6 National Dam Inspection Program. Number
Musser Forests Dam (NDIVPA-287,
DER IDV 32-65), Ohio River Basin, McKee
Run, Indiana County, Pennsylvania.

PHASE I ~~REPORT~~ Inspection Report,
NATIONAL DAM INSPECTION PROGRAM

NAME OF DAM: Musser Forests Dam
STATE LOCATED: Pennsylvania
COUNTY LOCATED: Indiana
STREAM: McKee Run
SIZE CLASSIFICATION: Small
HAZARD CLASSIFICATION: High
DATE OF INSPECTION: May 23 and 25, 1979

PLATE 6
 MUSSER FORESTS DAM
 GENERAL PLAN
 FIELD INSPECTION NOTES
 FIELD INSPECTION DATE: MAY 23, 79

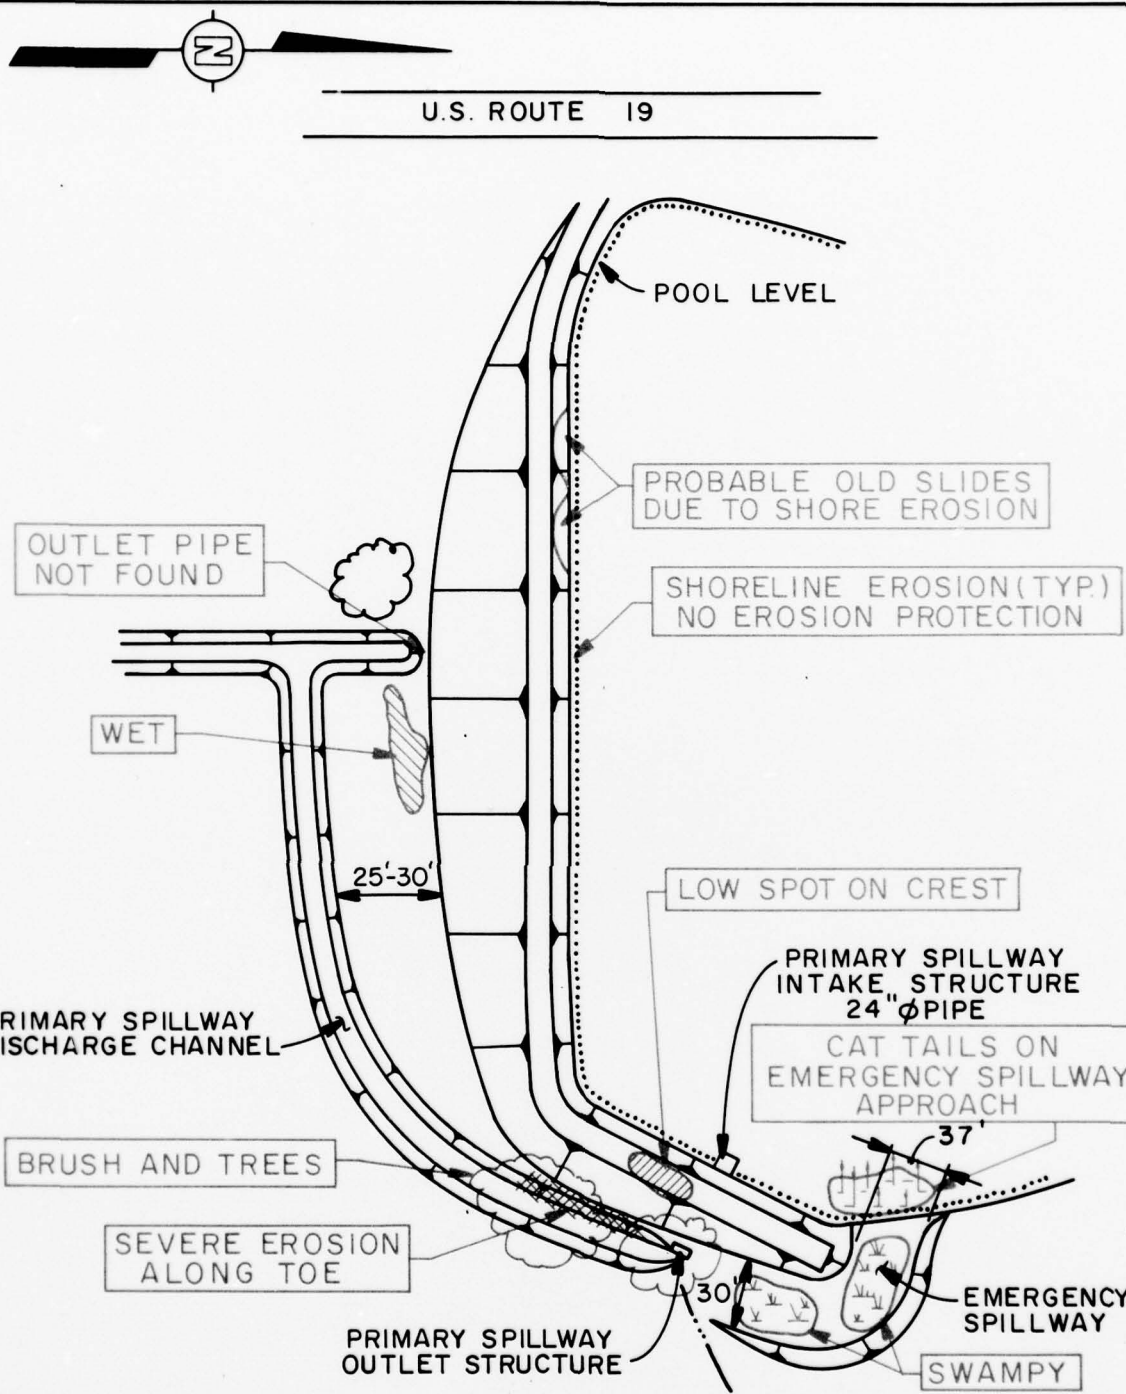
The specific observations are illustrated in Plate 6 and in the photographs in Appendix C.

Discharge through the primary spillway discharge channel which follows the toe of the embankment near the left abutment was found to be eroding the embankment toe. At some sections, the toe of the embankment appears to be cut 4 to 5 feet deep by this erosion. This condition is considered to constitute a threat to the integrity of the embankment if allowed to continue. The condition of the remaining portion of the embankment is considered to be fair. The crest of the dam was found to be irregular. However, the irregularities do not appear to be from recent movements. The upstream slope of the dam has no erosion protection and has eroded due to wave action. A wet area was observed at the toe level of the dam at the center of the main embankment. No measurable seepage appears to be associated with this wet area.

The emergency spillway approach channel was found to be overgrown with tall grass and cattails which may obstruct flow through the emergency spillway. The spillway discharge channel downstream from the primary spillway was also found to be overgrown with brush and trees which also may constitute obstruction to flow. Although the design drawings show the base width of the emergency spillway to be 50 feet, the field measurements show the base width of the emergency spillway to be approximately 37 feet. The visible portions of the primary spillway structures were inspected and found to be in fair condition.

1. The owner should immediately retain a professional engineer to evaluate the erosion in the primary and emergency spillway discharge channel and to prepare and execute plans for providing adequate erosion protection. This study should also consider means of providing emergency drawdown facilities or restoring and improving the existing facilities with upstream closure or control.

PLATE 7

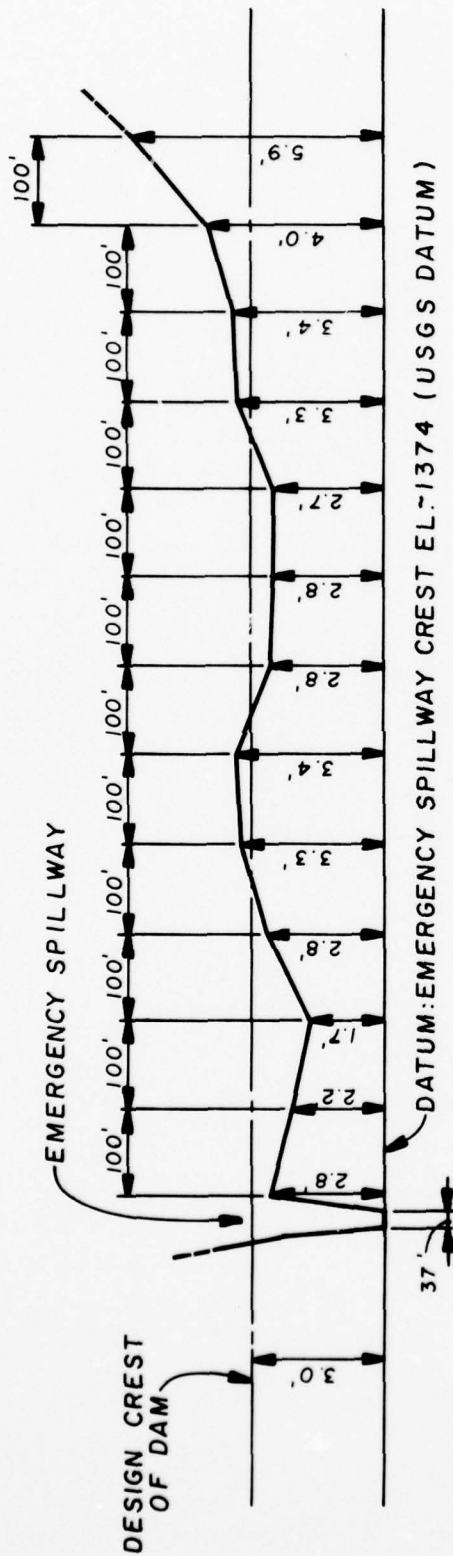
The crest of the dam was surveyed relative to the emergency spillway crest level. The freeboard was found to range from 1.7 feet in the vicinity of the primary spillway to 5.9 feet near the right abutment. The dam crest profile is illustrated on Plate 7.

2. The owner should immediately initiate additional studies to more accurately ascertain the spillway capacity and the nature and extent of improvements required to provide adequate spillway capacity. Filling of the low spots on the crest of the dam should be considered in conjunction with these studies.
3. Erosion protection, such as riprap, should be provided on the upstream slope of the dam.
4. Vegetation in the emergency spillway approach channel should be immediately cleared.
5. Around-the-clock surveillance should be provided during unusually heavy runoff and a formal warning system should be developed to alert the downstream residents in the event of emergencies.
6. The dam and appurtenant structures should be inspected regularly and necessary maintenance performed.

Photograph No. 6

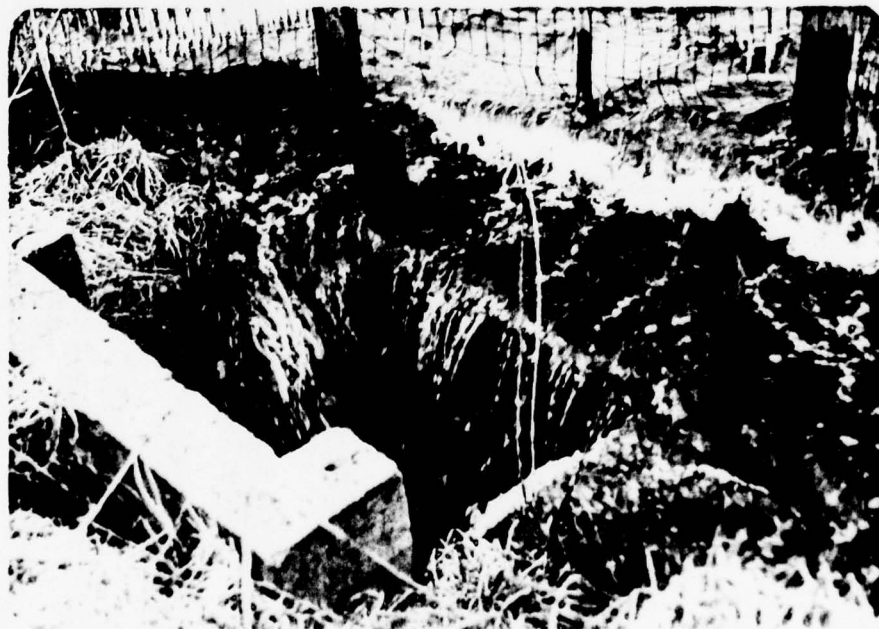
Primary spillway discharge channel. Note erosion along the toe of the dam.
